Our ref: Residential Flat Building at 64-66 Lavender St & 3-7 Middlemiss St, Lavender Bay (SSD-86797708)

Subject: Request for Additional Information

10. Basement storage

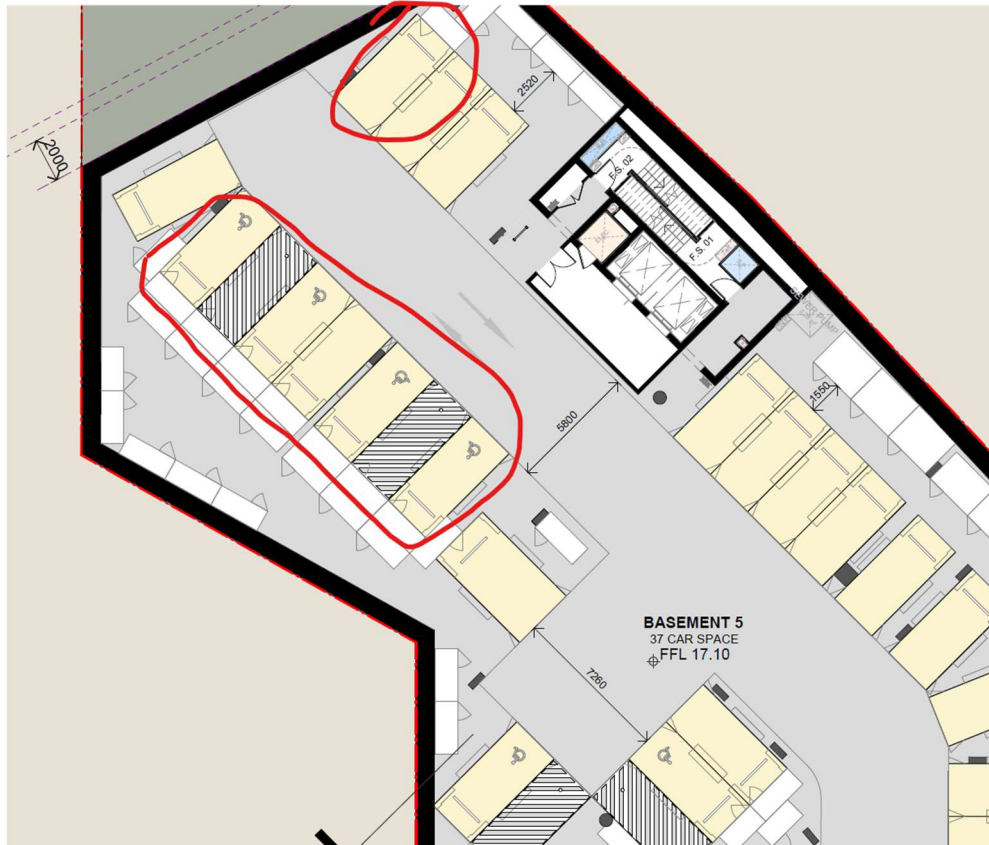
Part 4G-2 of the ADG provides guidance advising that storage areas external to apartments must be accessible. The storage areas to the north of the basement levels 2 to 5 appear to open into car parking spaces and would not be functional while cars are parked in these locations. These storage areas should be reconfigured to ensure they are fully accessible:
